DESIGN <i>[Signature]</i>	DRAWN BY <i>[Signature]</i>	DART AEROSPACE LTD HAWKESBURY, ONTARIO, CANADA	
CHECKED <i>[Signature]</i>	APPROVED <i>[Signature]</i>	DRAWING NO. DSI 9341	REV. A SHEET 1 OF 2
DATE 06.08.09		TITLE BLOWER MOTOR ASSEMBLY	SCALE 1:1
A	06.08.09	NEW ISSUE

DART SERVICE INSTRUCTION

TO AMEND INSTALLATION INSTRUCTIONS IIN-D206-746 REV.A

REF. CANADIAN STC: SH05-45 ISSUE 1

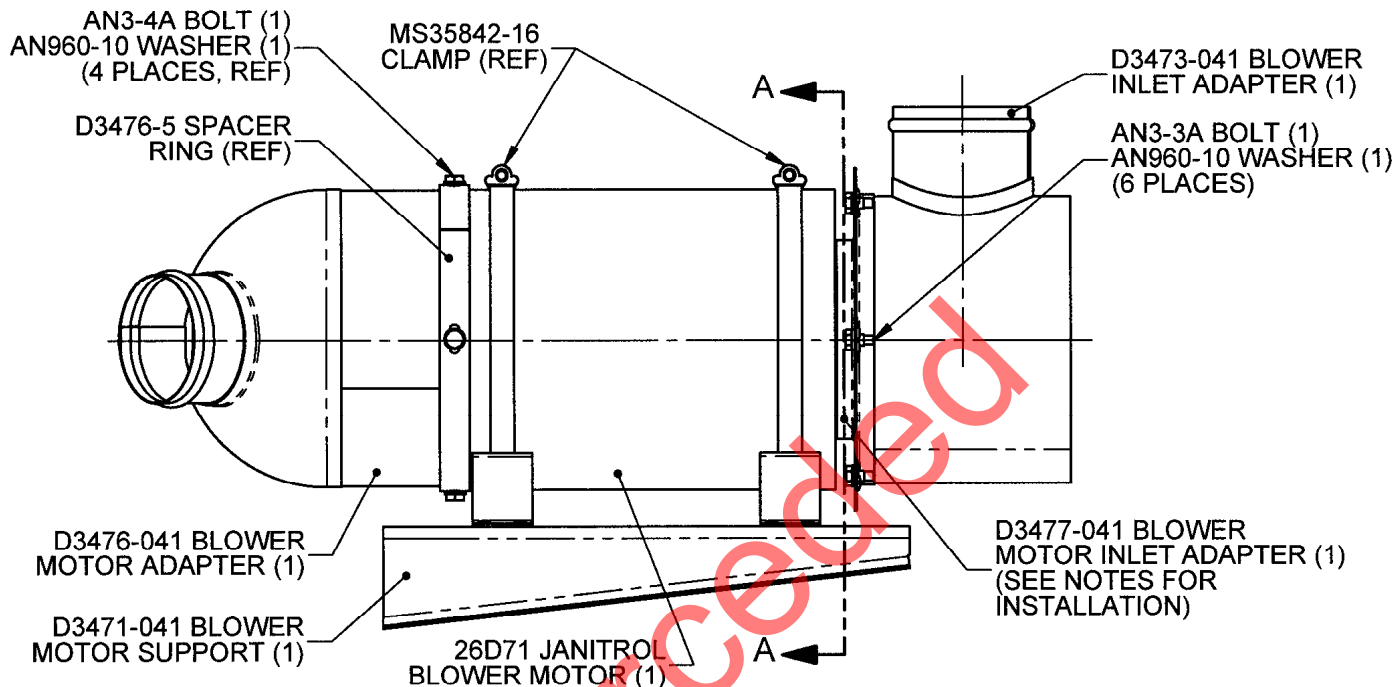
The Parts List of Installation Instructions IIN-D206-746 Rev. A should be amended as follows:

Furthermore, any mention of "Blower Motor Assembly" appearing in Installation Instructions IIN-D206-746 Rev. A, and Installation Drawing D206-746 Rev. A, should be replaced by D206-746-043 Blower Motor Assembly.

D206-746-043 BLOWER MOTOR ASSEMBLY

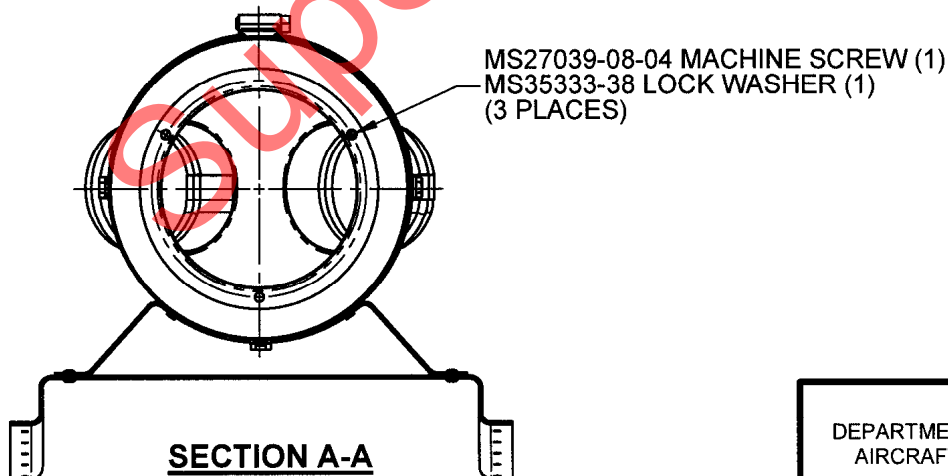
For assembly instructions of D206-746-043 Blower Motor Assembly, refer to page 2 of this DSI.

- 1) ON 26D71 BLOWER MOTOR, REMOVE EXISTING MACHINE SCREWS (3), LOCK WASHERS (3) AND EXISTING ADAPTER (1).
- 2) REPLACE ADAPTER WITH D3477-041 BLOWER INLET ADAPTER. USE HARDWARE REMOVED AT STEP 1 TO SECURE D3473-041 BLOWER INLET ADAPTER TO 26D71 JANITROL BLOWER MOTOR.
- 3) D206-746-043 IS SUPPLIED TO CUSTOMER PRE-ASSEMBLED.
